***MIL-STD-1580 (DPA FOR EEE PARTS)
TASK GROUP STATUS***

ELECTRONICS TECHNOLOGY WORKSHOP

Item 12

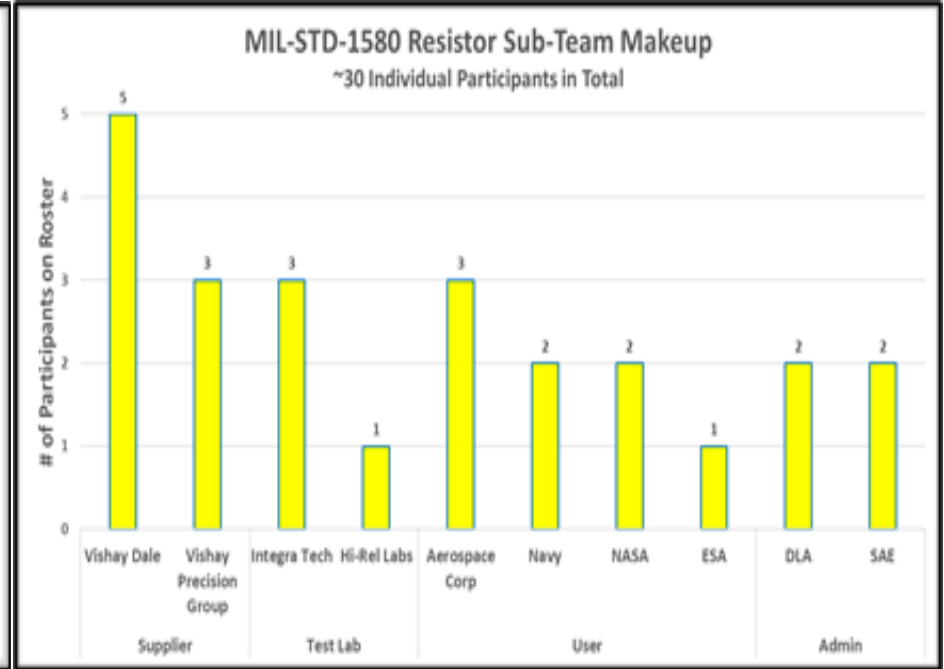
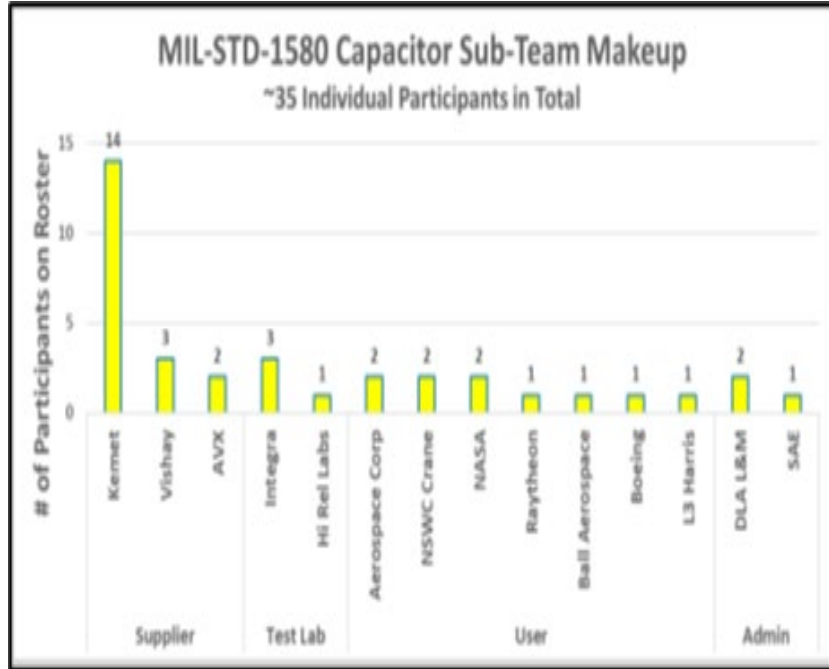
Requirement 13, paragraph 13.3.1.3 (hermetic seal) – This paragraph states that gross leak testing shall not be according to condition C. However, the statement ends with “no bubbles or fluorescent residue should be present” which is a bit contradicting given that condition C shall not be performed.

“The devices shall be tested according to method 1071 of MIL-STD-750. Fine leak testing shall be according to condition G or H. Gross leak testing shall not be according to condition C. ~~No bubbles or fluorescent residue should be present”.~~

“Conditions C is prohibited for MIL-PRF-19500 product.....”

Section 10.11 DPA for Single Anode Solid Tantalum Chip Capacitors and Section 10.12 DPA for Multi-Anode Solid Tantalum Chip Capacitors

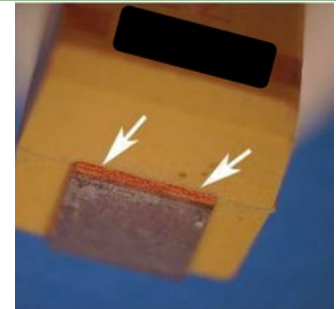
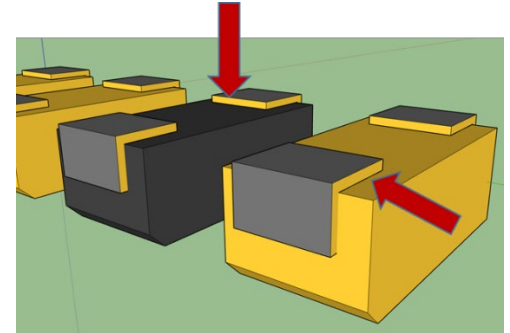
Replace paragraphs for Prohibited Materials Analysis (PMA) as noted below

Rationale: Leadframes used for tantalum chip capacitors are sometimes made from stamped and formed brass substrates where the brass alloy contains > 5% Zinc by weight. The stamping/forming operations may produce small areas of exposed base metal that would fail to meet the existing MIL-STD-1580 section 9 PMA requirements. The capacitor team consensus was to recommend waiving the PMA requirements for these small areas of exposed Zn-containing alloys unless they amount to a significant sized area that may compromise meeting standard solderability requirements (i.e., > 5% of total solderable surface area)

<p><u>OLD</u></p> <p>10.11.1.3 Prohibited Materials Analysis (PMA). Prohibited materials analysis shall be performed according to Section 9 of this document. (1 sample) except that only external analysis is required.</p>	<p><u>NEW</u></p> <p>10.11.1.3 Prohibited Materials Analysis (PMA). Prohibited analysis shall be performed on one sample according to § this document, except that only external analysis is required areas of exposed Zn-containing base metal are acceptable not collectively exceed 5 percent of the total solderable surface of the terminations.</p>
<p><u>OLD</u></p> <p>10.12.2 Prohibited Materials Analysis (PMA). Prohibited materials analysis shall be performed according to Section 9 of this document. (1 sample) except that only external analysis is required.</p>	<p><u>NEW</u></p> <p>10.12.2 Prohibited Materials Analysis (PMA). Prohibited materials analysis shall be performed on one sample according to § this document, except that only external analysis is required areas of exposed Zn-containing base metal are acceptable not collectively exceed 5 percent of the total solderable surface of the terminations.</p>
